Modification Application - Regulation 22

Interest Holder	Central Petroleu	m Limited	EMP NT Drilling	g Campaign	Unique EMP ID No.	CTP 3.4	Mod 3 No.	Date	11 August 2021
Brief Description	The NT Drilling Campaign EMP was approved by the Minister on 29 November 2020. The description of activities included construction of access tracks, vehicle turnarounds, etc. In relation to the PV12 well, Central would like to widen the existing access track to the new well pad location. The access track is currently in operation and within the existing Palm Valley field. The modification is necessary to ensure the drill rig and the associated infrastructure can be safely mobilised and to provide a suitable area where vehicles and can pass safely. The widening of the existing track will result in an additional 0.05 hectares (approximately) area needing to be cleared, highlighted in purple in Appendix A. An ecology survey has recently been undertaken (Appendix C) and based on the results, they concluded that 'the environmental impact of widening the loop will be minimal and will have no significant impact on plant species populations in the area, region or nationally'. In addition the access track an

See Appendix 1	See Appendix 2
	Figure 4-5a Palm Valley 6 Intersection
	This figure has been added to supplement Figure 4-5. These combined figures provide details of the areas to be cleared in relation to the PV12 drilling program.

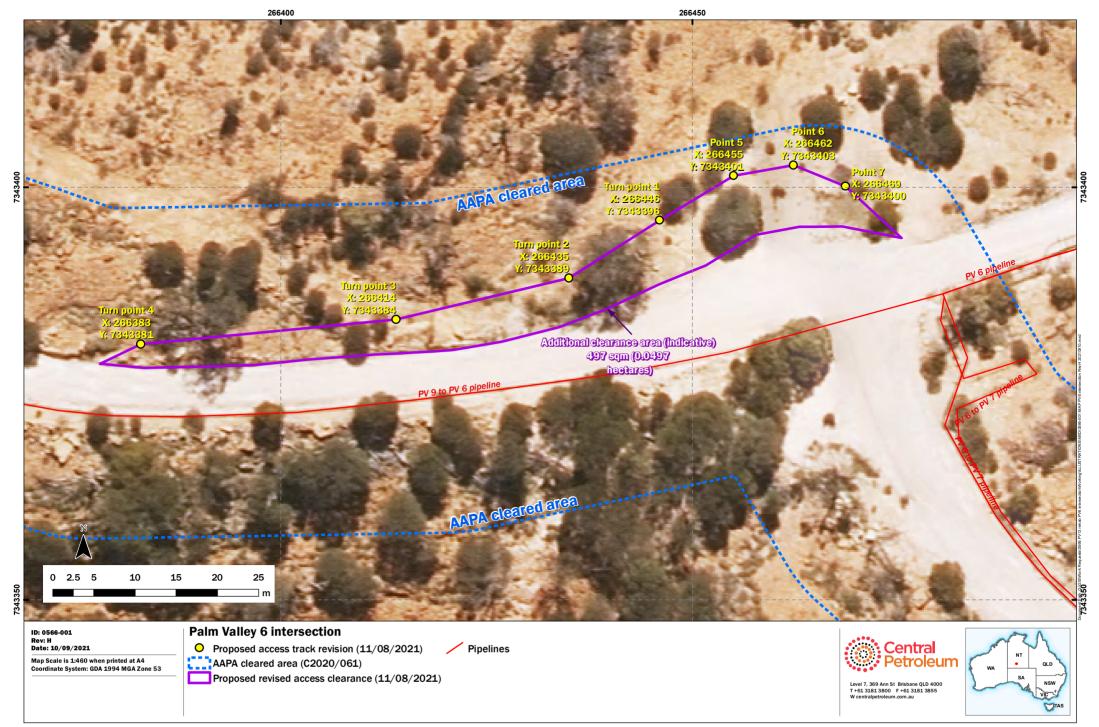
Current EMP Text	Amended EMP Text
4.3 Civil works	4.3 Civil works
The civil works required to support the drilling campaign includes:	The civil works required to support the drilling campaign includes:
Construction of access tracks to the well leases as outlined in Figure 4-1 to Figure 4-6 Width of the access track will be up to 8 m dependent upon the constraints at each location. Passing turnouts will be located intermittently along the track so that vehicles can safely pass each other. The turnouts will be located in areas with no constraints.	Construction of access tracks to the well leases as outlined in Figure 4-1 to Figure 4-6 Width of the access track will be up to 16 m dependent upon the constraints at each location. Passing turnouts will be located intermittently along the track so that vehicles can safely pass each other. The turnouts will be located in areas with no constraints.
Table 4-1 Proposed Ground Disturbance Areas	Table 4-1 Proposed Ground Disturbance Areas

Well Location	Survey Clearance Area (Ha)	Access disturbance area (Ha)	Flowline disturbance area (Ha)	Camp disturbance area (Ha)	Area (Ha)	Total Disturbance (Ha)	% of permit
PV12	12	0.19	0.29	-	2.21	2.69	0.004%

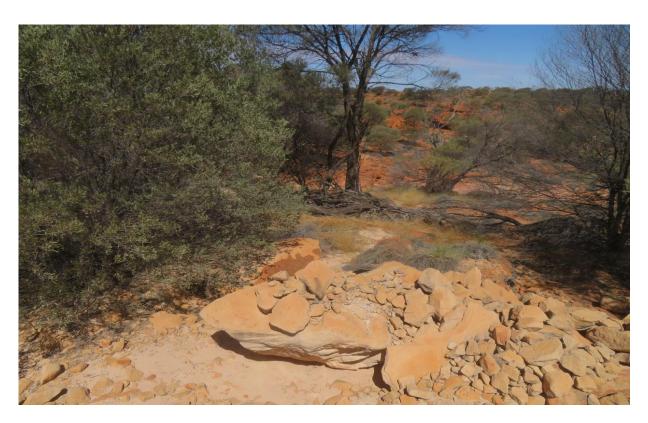
The area is a fire shadow area and the large mulga at point 2 should be conserved if possible, possibly by pruning the parts of the tree overhanging into the turning area. In all areas, every effort should be made to minimise the total area affected. In no case is a vehicle to be driven off the road except at the existing turn around and passing points.

Fig 2: This old Acacia aneura, Mulga, is within the proposed clearing corridor. While it may be possible to prune the tree to allow the road train clearance, removal of the sandstone base will likely remove significant roots. The species is common, but the tree occurs in a fire shadow area and has been able to survive for a hundred or more years.

Only those trees and shrubs which impinge into the parts of the road to be widened should be removed or pruned. Trees and shrubs which are felled or pushed with the dozer or grader should be placed into the adjacent bush and allowed to decompose naturally. Any topsoil recovered should be used in areas requiring rehabilitation or restoration of vegetation.
